ADDENDUM NO. 2

DATE: April 13, 2015

Contract 14-C-00054; Blue Sink Water Main

Des:	JH	W.O. 7410	File: BLUE SINK
Dwn:	JDM	FILE NUMBER	
Ckd:	JRD	SHEET 20	OF 31

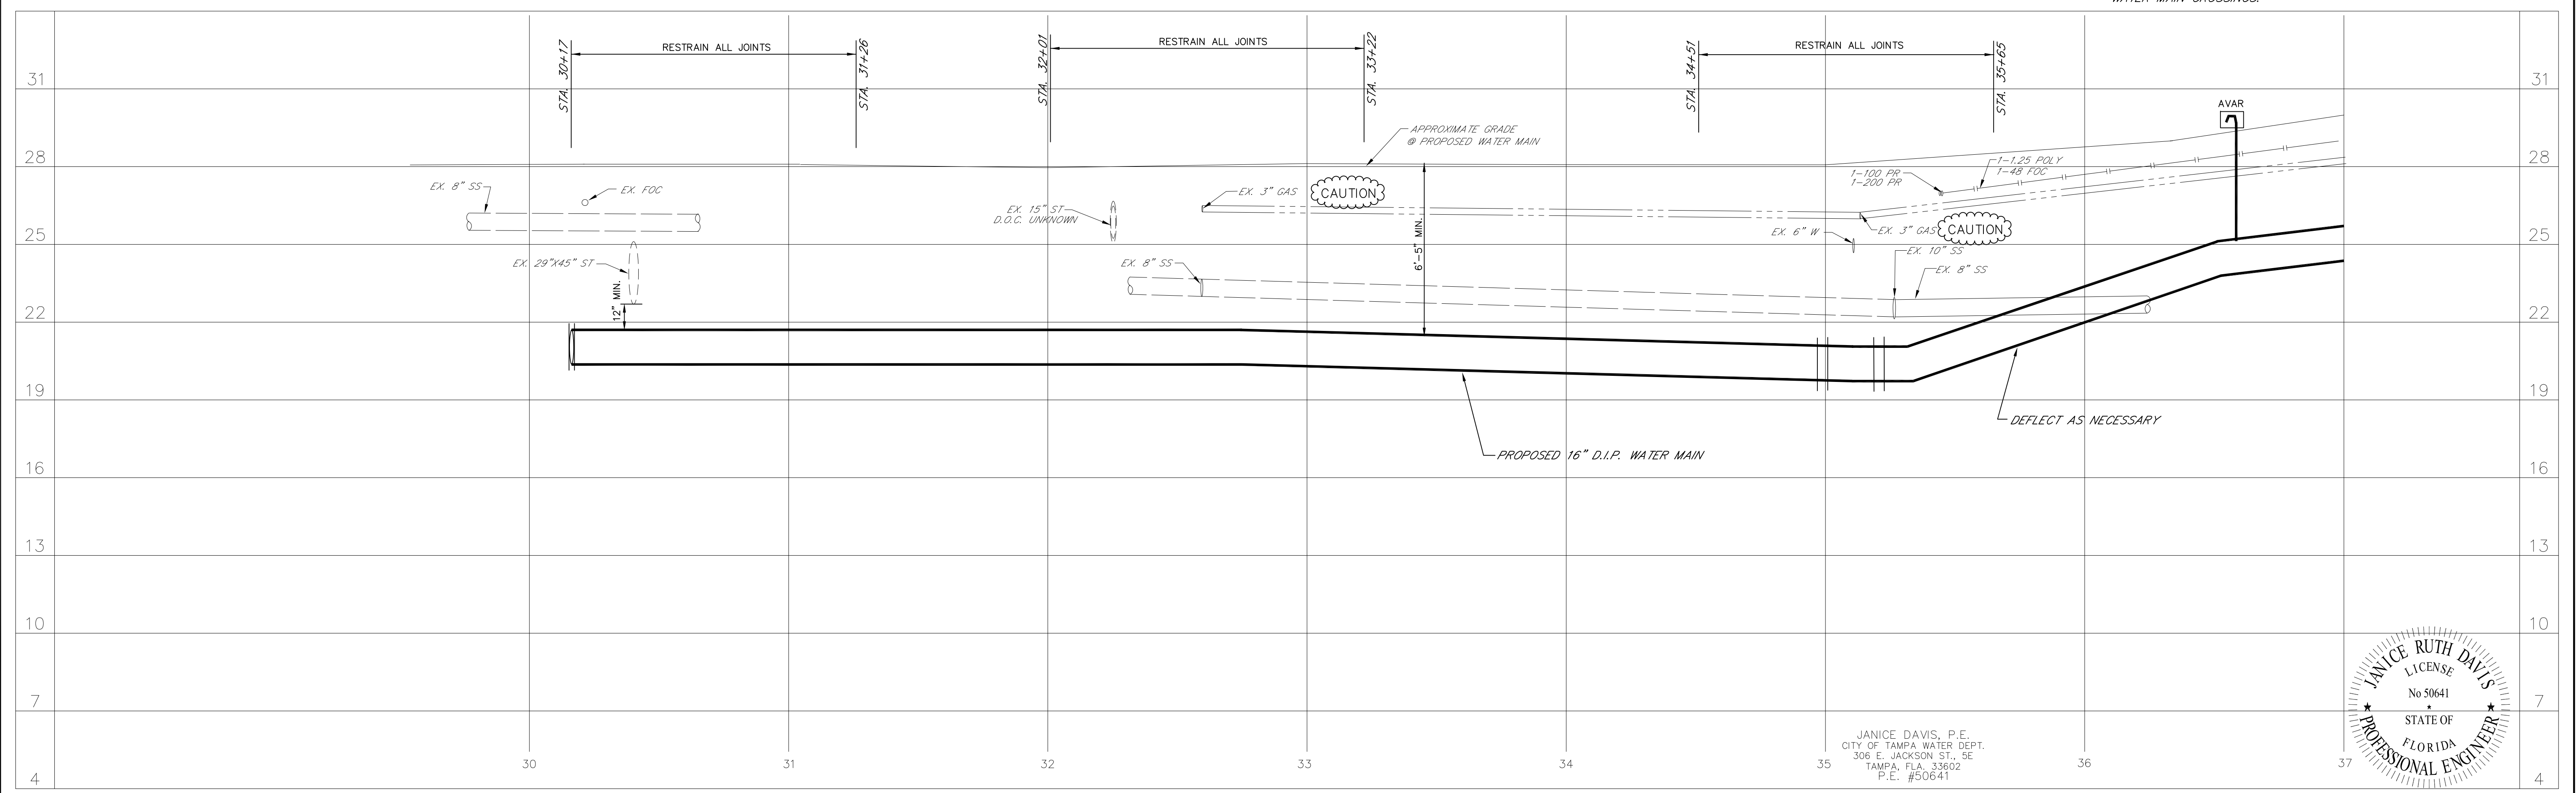
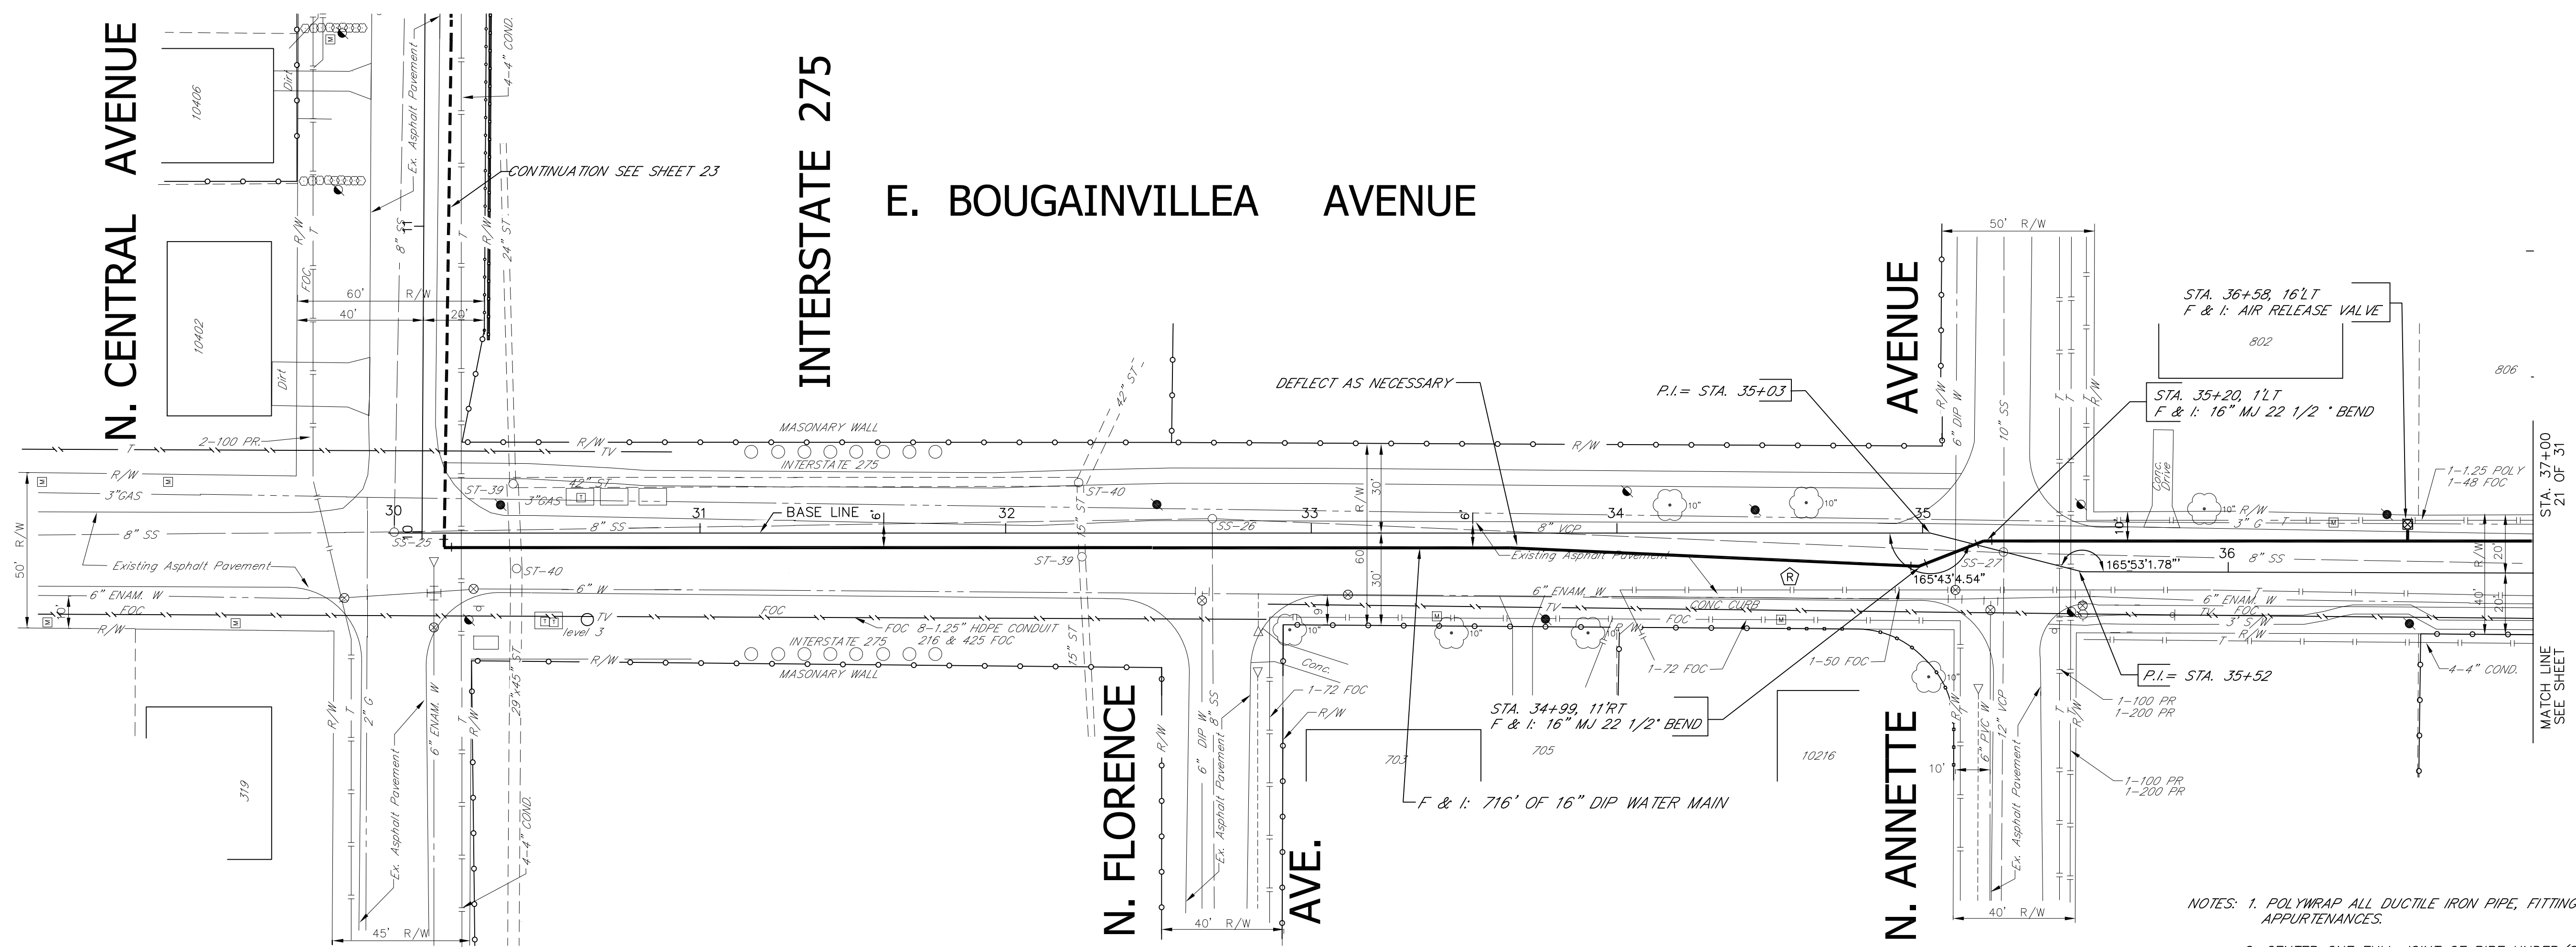
Atlas Page	No. 1	Date	3/24/15	REVISION	ALIGNMENT	By	JDM
	B12-2						
Approved		Date

KEY SHEET

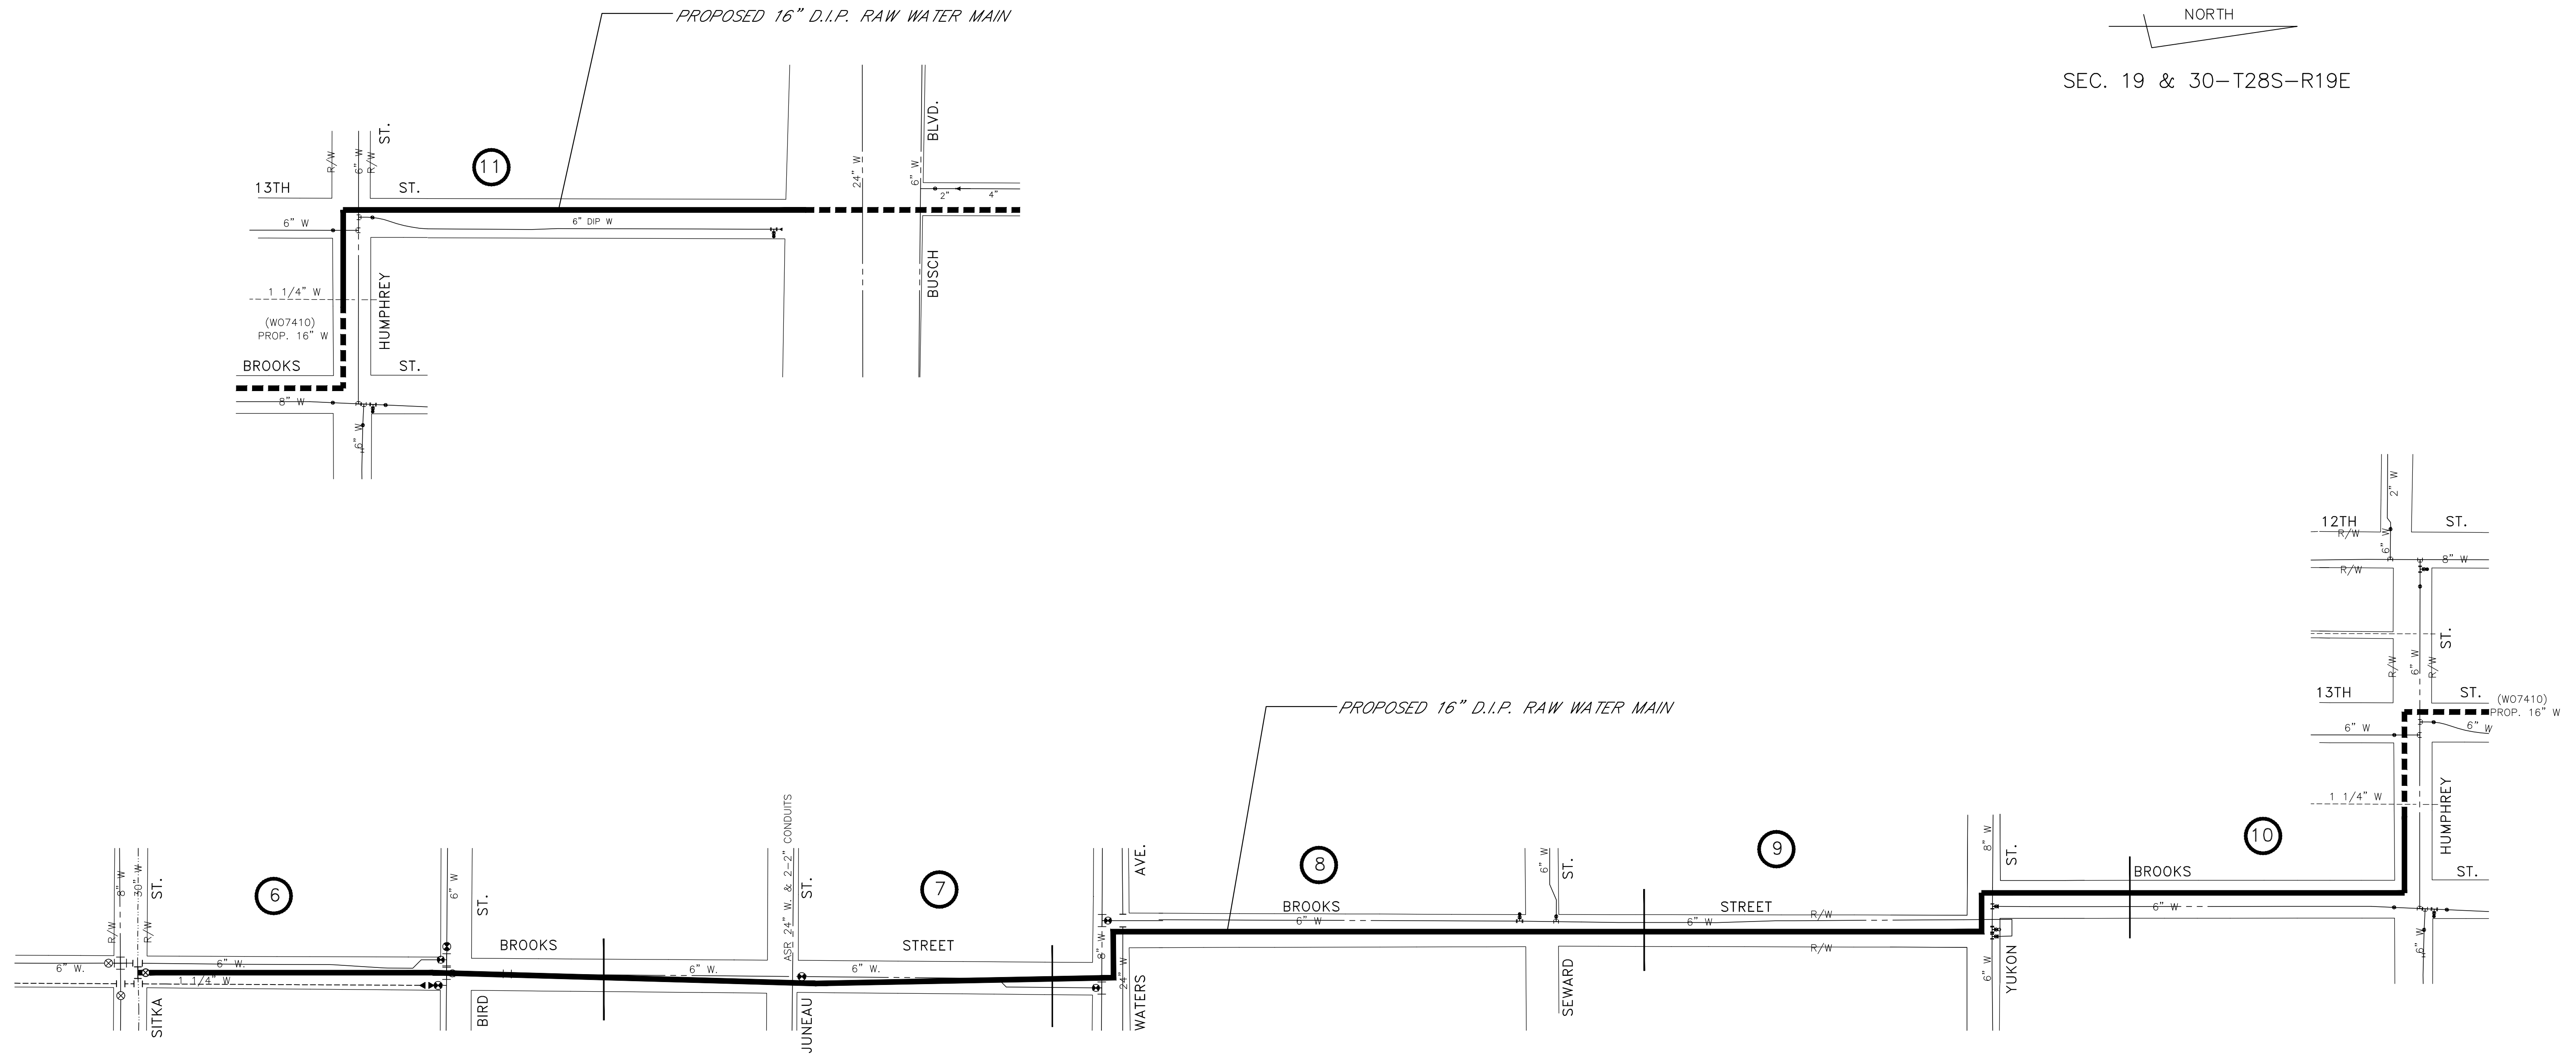
Atlas Page	1	4/9/15	ADDED S/W, D/W AND PHONE CABLE	PF	Des:	JRD	W.O. 7410	FILE: BLUE SINK
C13-3	No.	Date	REVISION	By	Dwn:	PF	FILE NUMBER	
D13-4	Approved	Date			Ckd:	JRD	SHEET 2	OF 31
